**PORTAGE COUNTY
EMERGENCY OPERATIONS CENTER**

HAI Project No. 22048.001

To: All Bidders

This Addendum becomes a part of the Contract Documents and modifies the original Bidding Documents dated 4-25-2023, as noted below. The Bidder shall acknowledge receipt of this Addendum on the Form of Proposal. Failure to do so may subject the Bidder to disqualification.

CHAIN LINK FENCE DETAILS

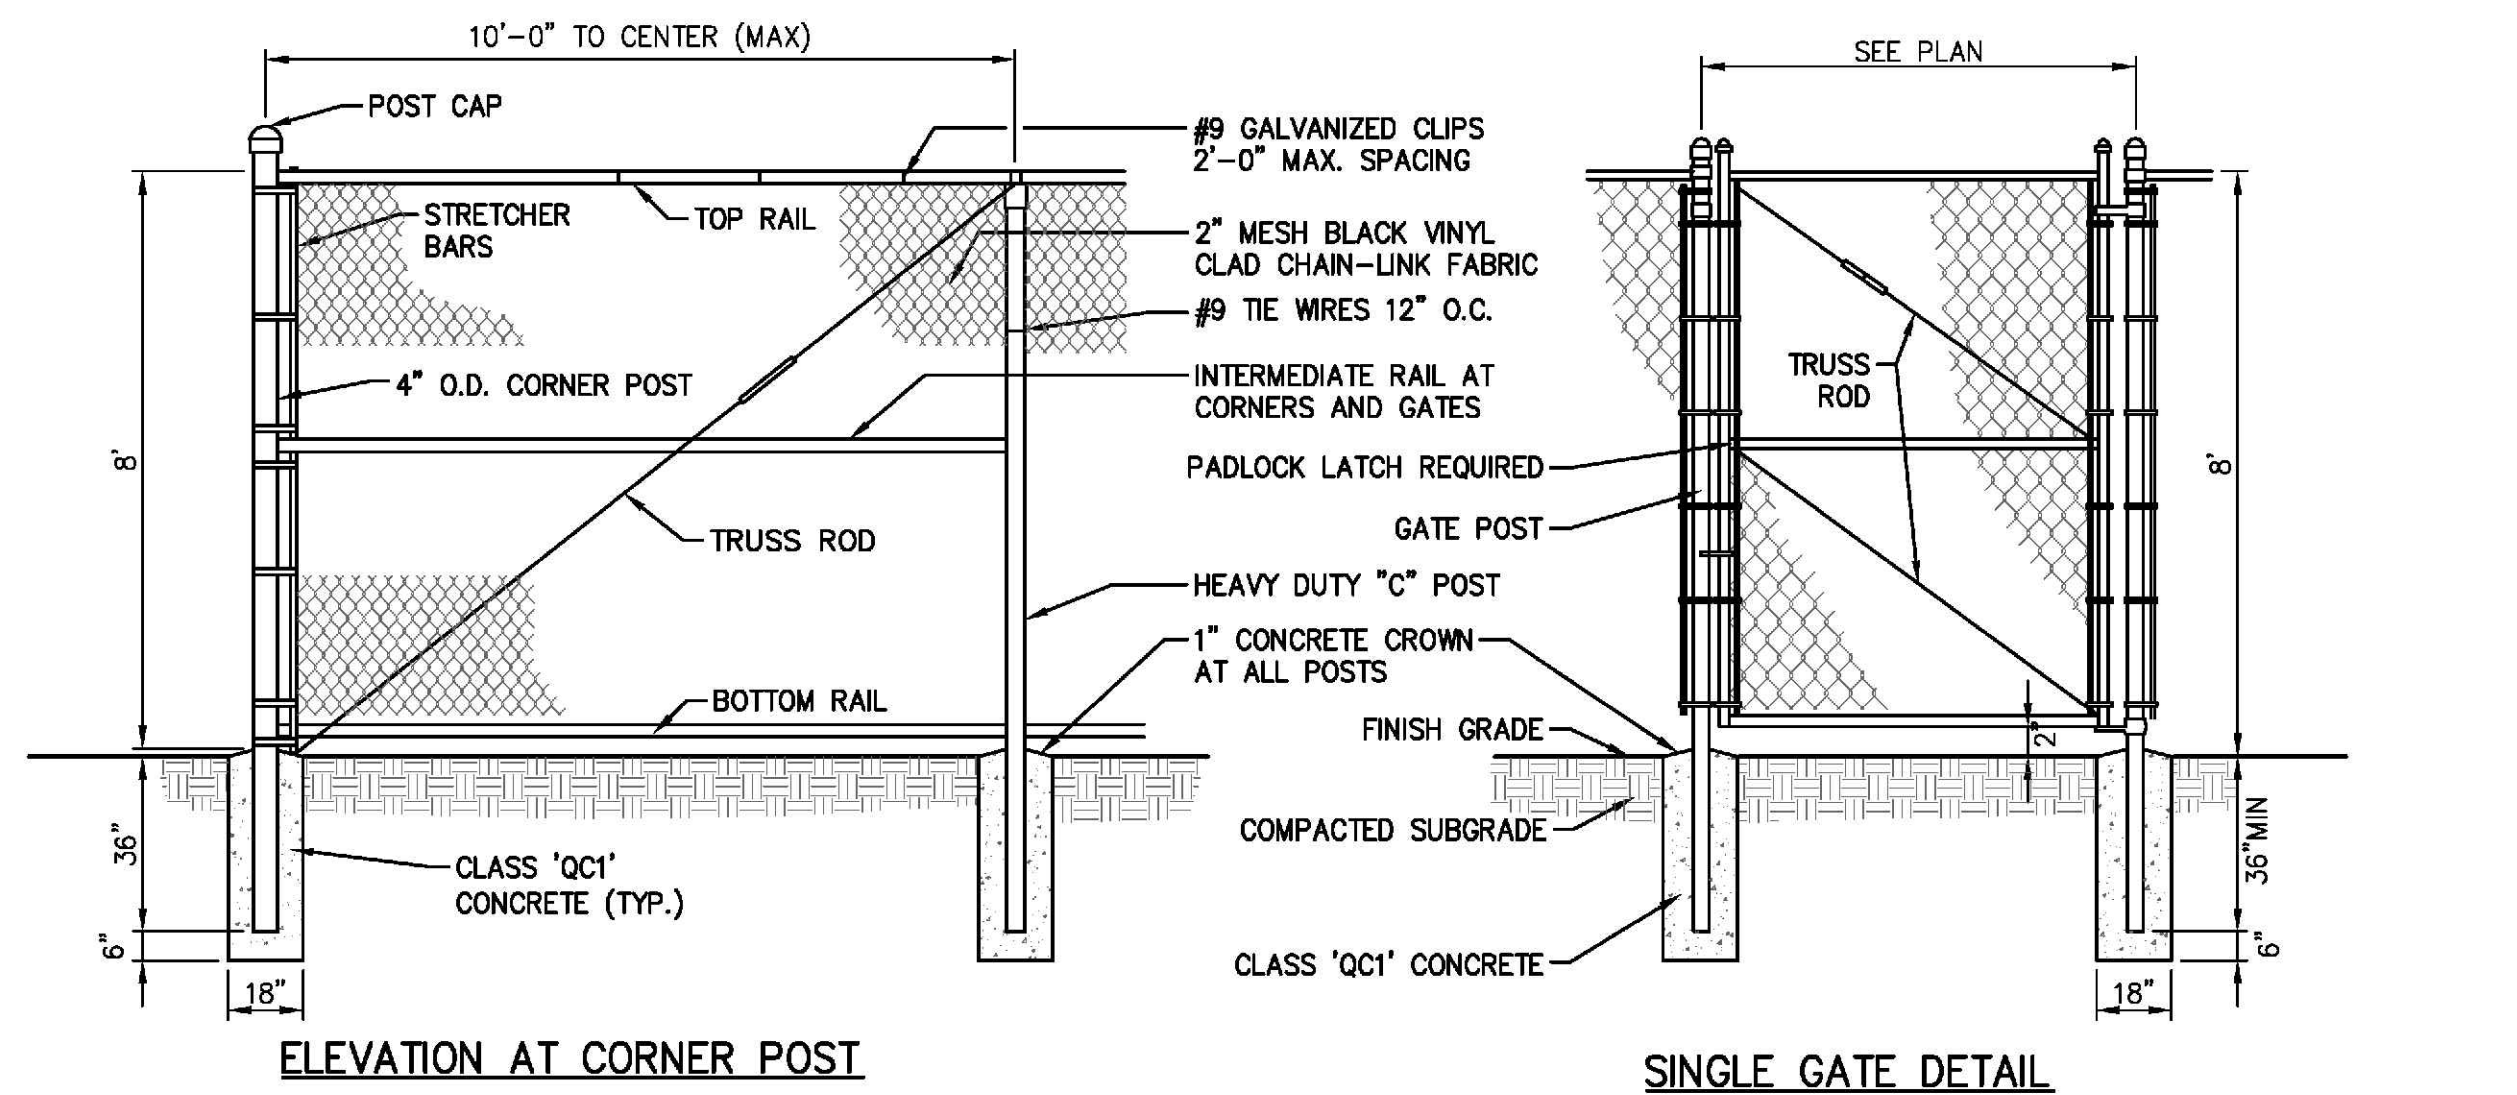
8. The slide gate as it appears on drawing C-2 does not have enough room to open. There is 24ft between the gate opening post and the fence corner post. but the gate has an over-all length of 30ft +.

- a. **THE GATE DESIGN AND LENGTH OF COUNTER-BALANCE WILL BE AS RECOMMENDED BY THE GATE MANUFACTURER. THE WIDTH OF THE GATE IN THE OPEN POSITION IS TO BE A MINIMUM OF 18 FEET.**

STYLE "CB"™ SEWER SADDLE

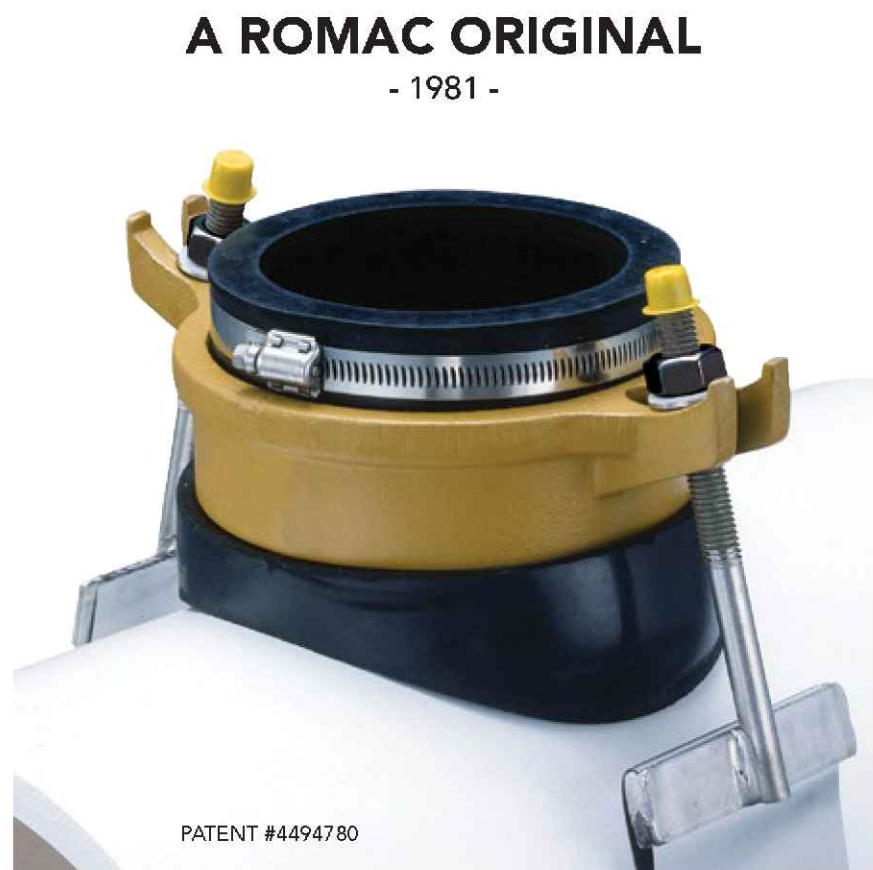
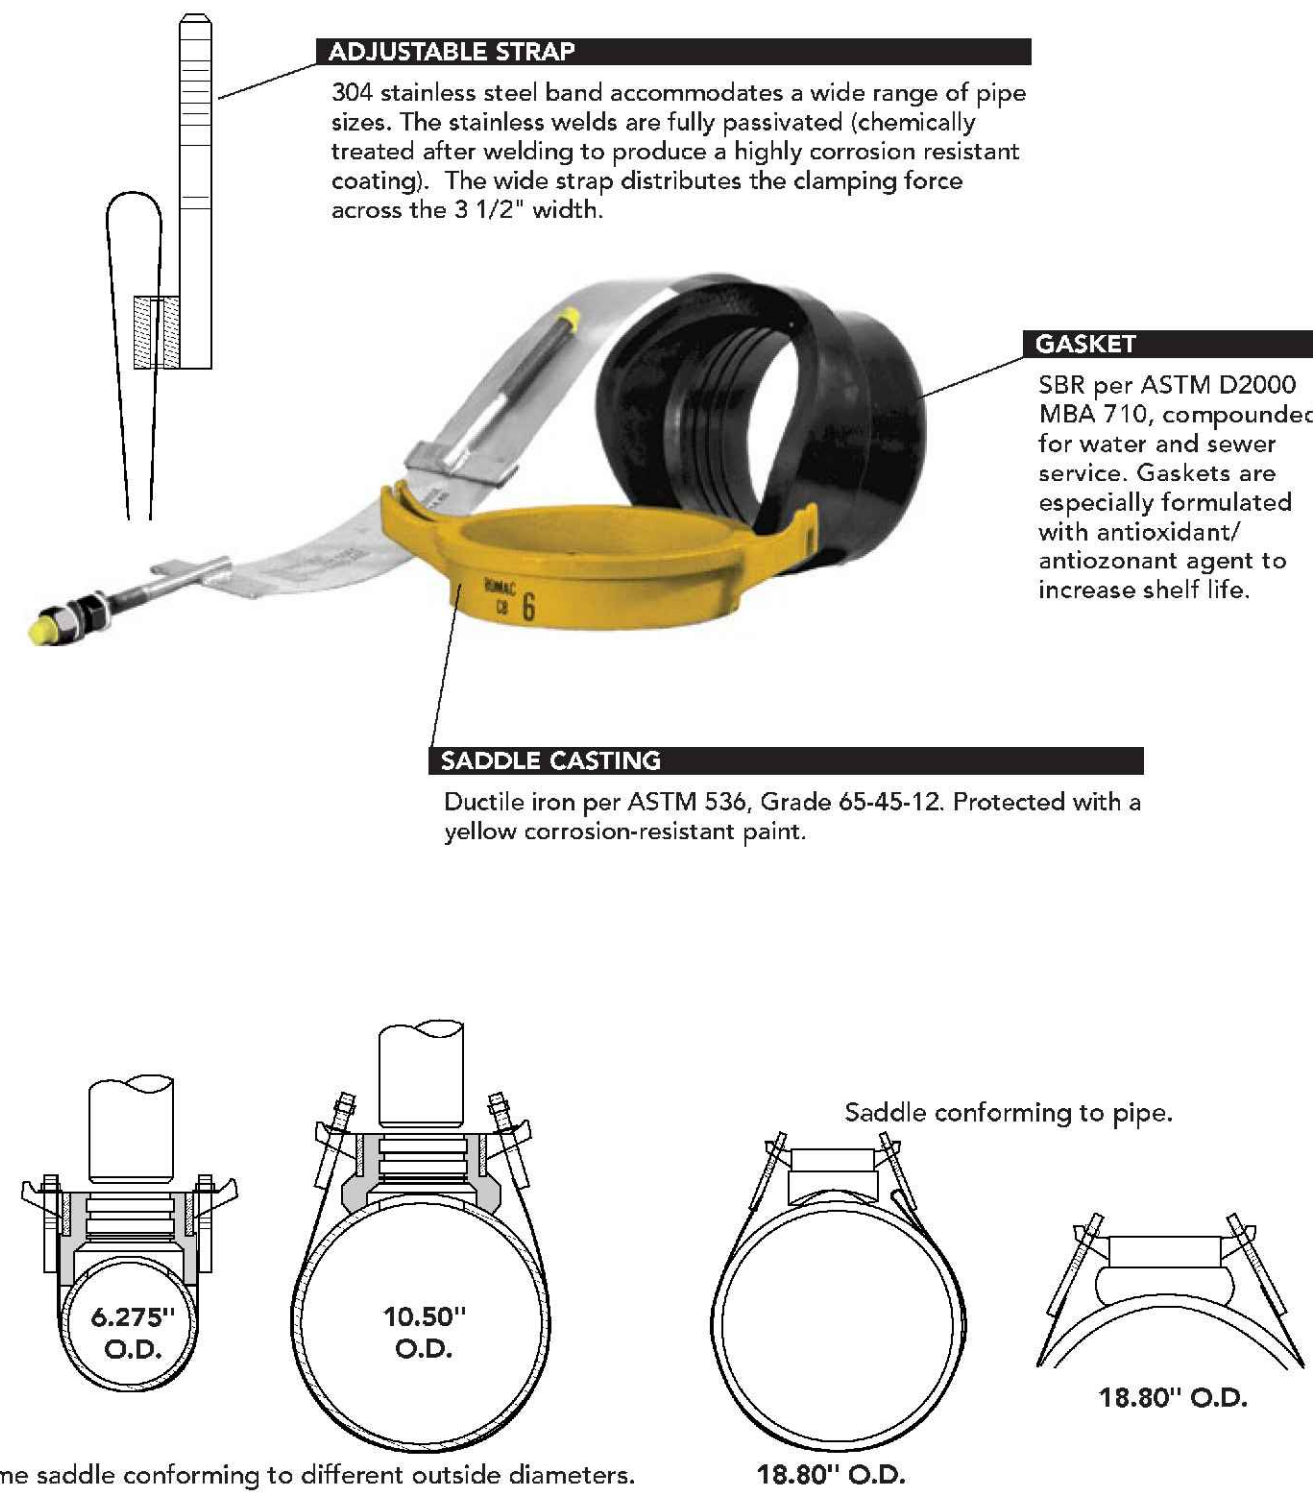
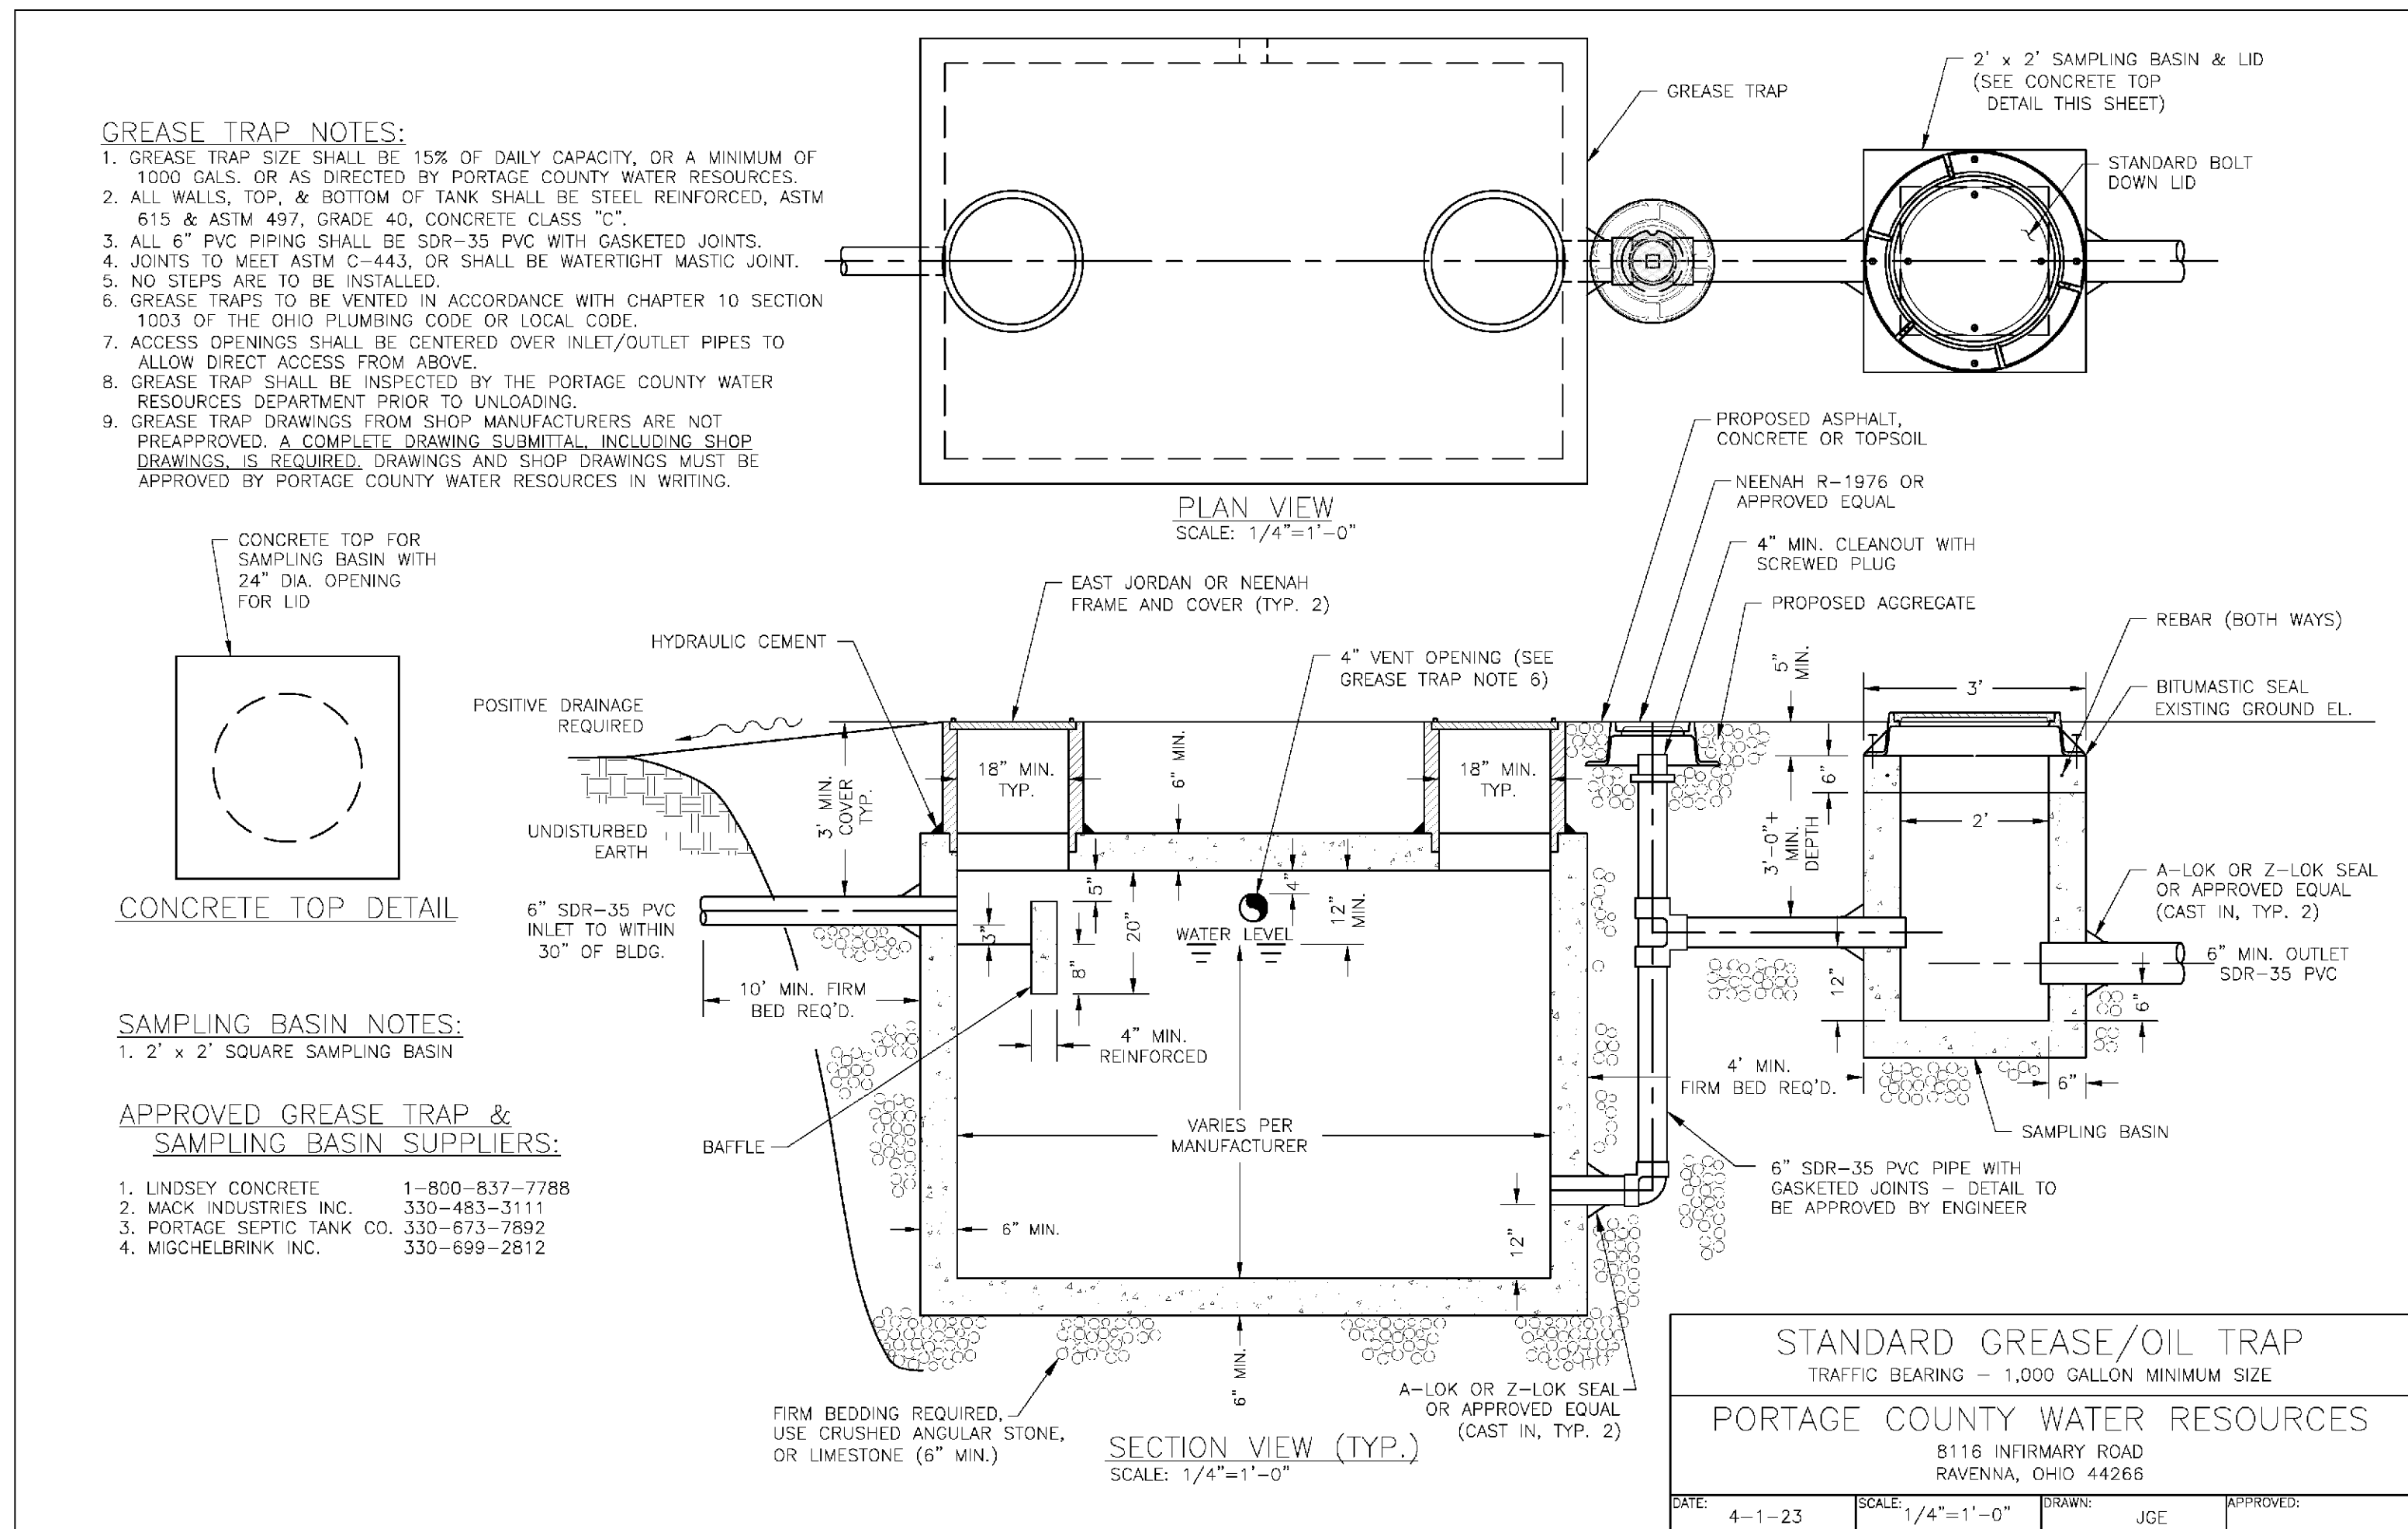
- a. C-1 EXISTING CONDITIONS AND DEMOLITION PLAN
 1. ADDED REMOVAL OF EXISTING SEWER FOR INSTALLATION OF NEW GREASE / OIL INTERCEPTOR.
- b. C-3 UTILITIES PLAN
 1. ADDED OIL / GREASE INTERCEPTOR.
 2. REVISED FORCE MAIN LENGTH AND CONNECTION TO EXISTING SEWER.
 3. REVISED SANITARY STRUCTURE AND PIPE SCHEDULES.
 4. ADDED KEYED NOTES, SANITARY SEWER NOTES.
- c. C-9 CONSTRUCTION NOTES AND DETAILS.
 1. ADDED PUMP STATION PROJECT SPECIFIC NOTES.
- d. C-11 CONSTRUCTION NOTES AND DETAILS.
 1. ADDED PORTAGE COUNTY WATER RESOURCES TYPICAL DETAILS.
 2. ADDED "ROMAC" TYPE CB SEWER SADDLE SPECIFICATIONS.
